Supplementary Information

**Proposed Temporary Place of Recreation, Sports or Culture (Hobby Farm and Fishing Ground),
Holiday Camp, Barbecue Site and Animal Boarding Establishment with Ancillary Facilities and
Associated Filling of Land for a Period of 3 Years in "Agriculture" Zone,
Various Lots in D.D.135 and Adjoining Government Land, Pak Nai, Yuen Long, New Territories**

(S.16 Planning Application No. A/YL-PN/91)

Departmental Comments	Applicant's Responses
Comments of the Chief Engineer/Mainland North, Drainage Services Department (Contact Officer: Mr. Daniel CHAN; Tel: 2332 2471)	
Comments received on 6.5.2026

CATCHPIT WITH TRAP
(SHEET 1 OF 2)

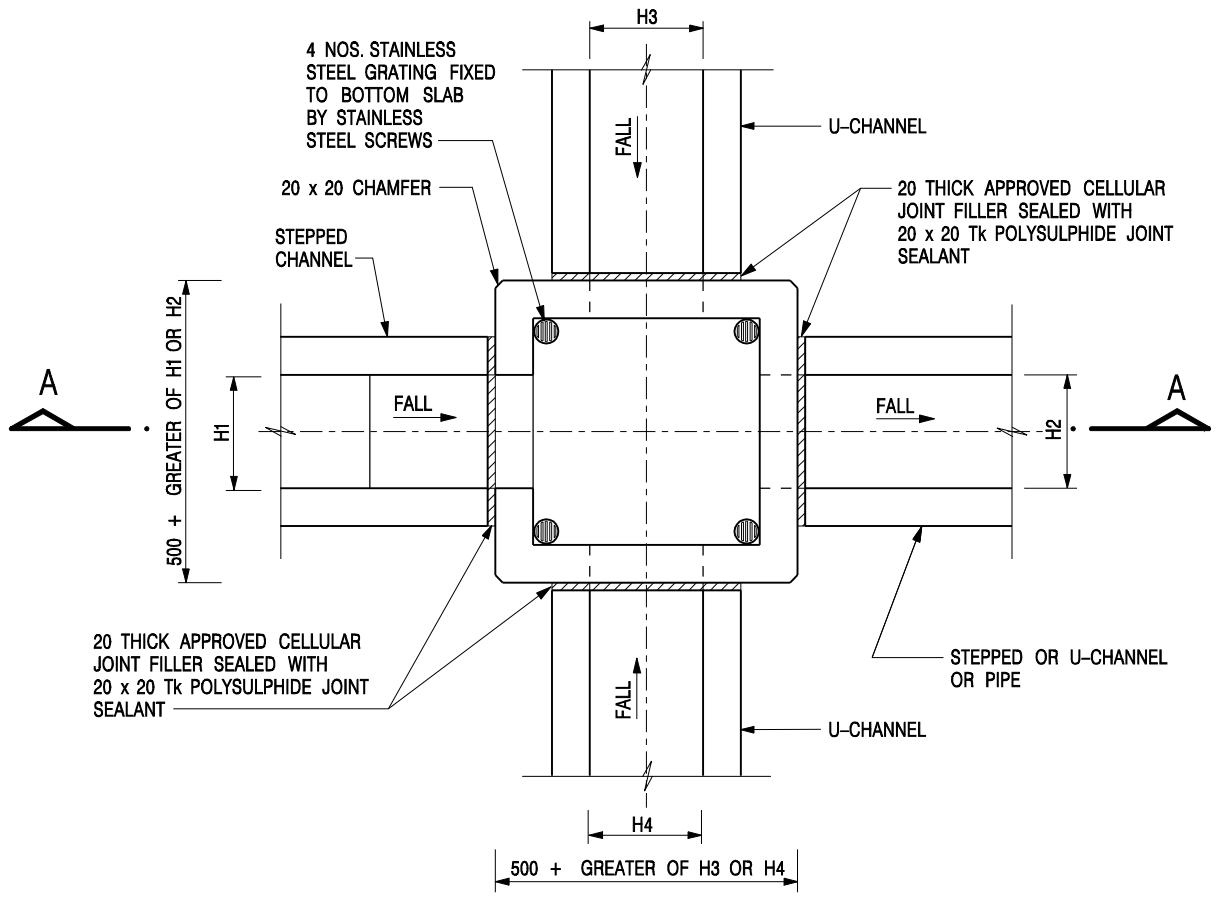
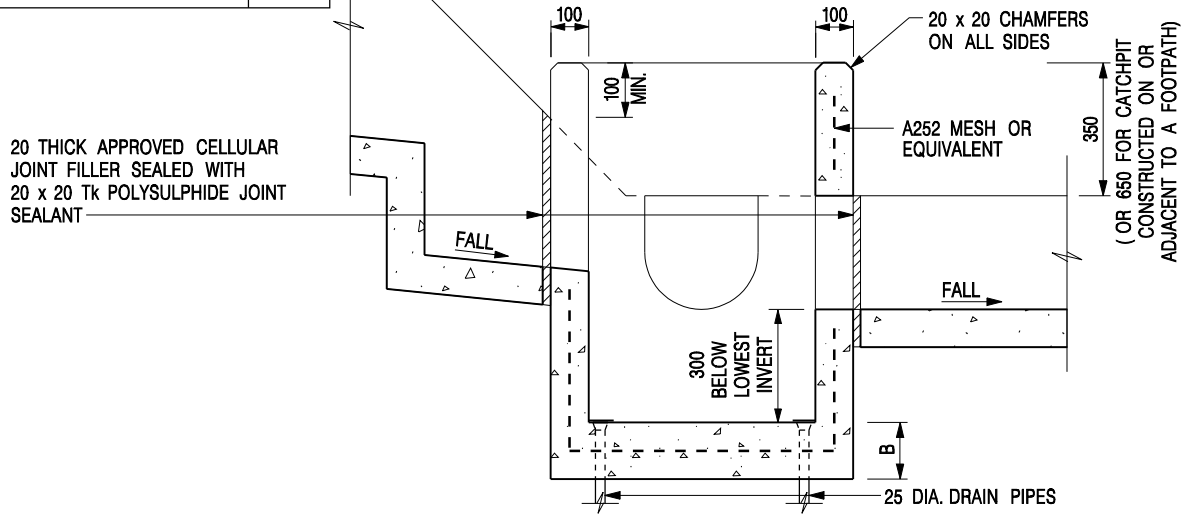
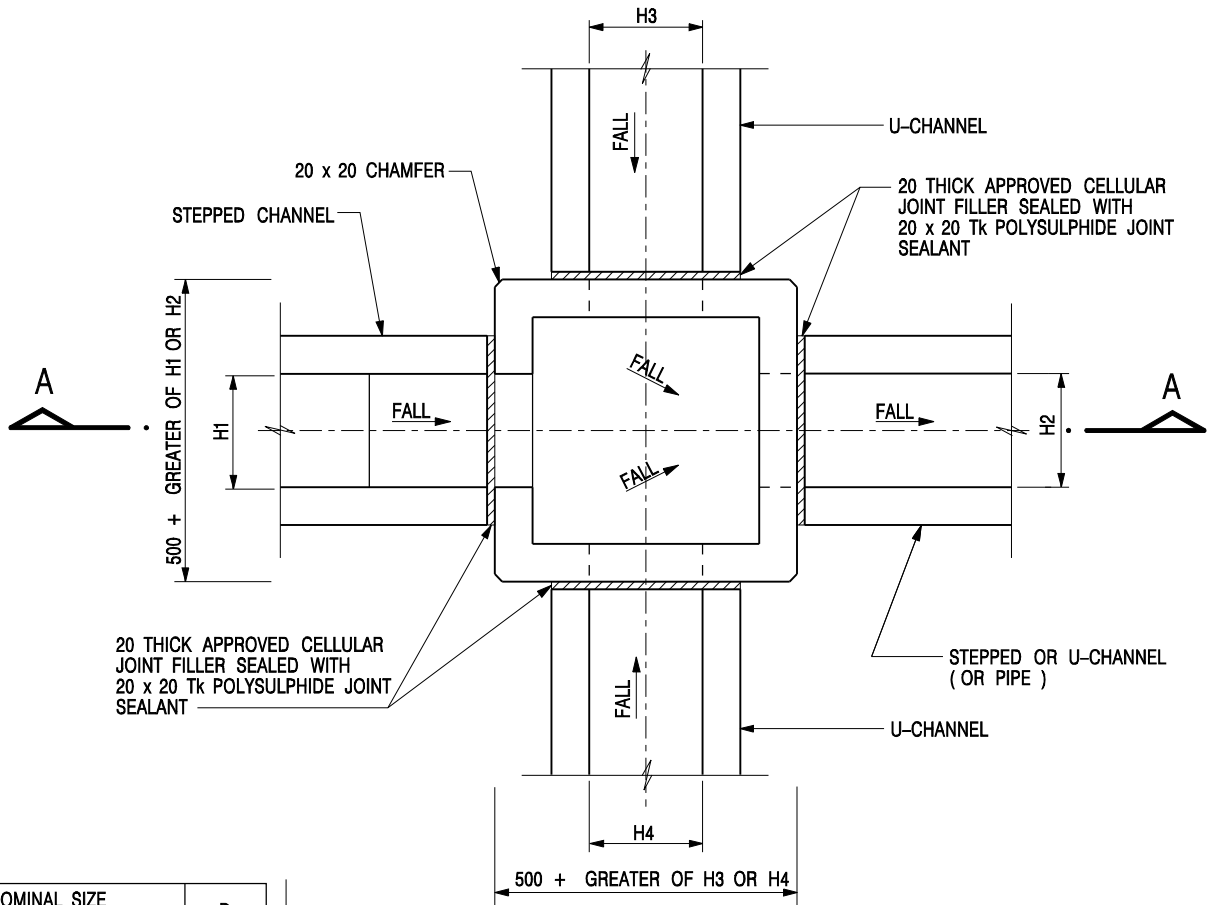
<p>(i) Sand trap or provision alike should be provided before the collected runoff is discharged to the public drainage facilities.</p>	<p>A catchpit with trap would be provided at the last catchpit before discharging to the existing stream. Please refer to Drawing No. DL1.</p>
<p>(j) Where walls or hoarding are erected are laid along the site boundary, adequate opening should be provided to intercept the existing overland flow passing through the site.</p>	<p>Noted.</p>
<p>(k) The development should neither obstruct overland flow nor adversely affect existing natural streams, village drains, ditches and the adjacent areas, etc.</p>	<p>Noted.</p>
<p>(l) Consideration should be given to provide grating for the surface</p>	<p>Steel Grating would be provided for the proposed U-channel. Standard Drawing No. is included in Appendix E.</p>
<p>(m) Appendix D - the location of photo 4 is unknown.</p>	<p>The location of photo 4 has been provided in Appendix D.</p>
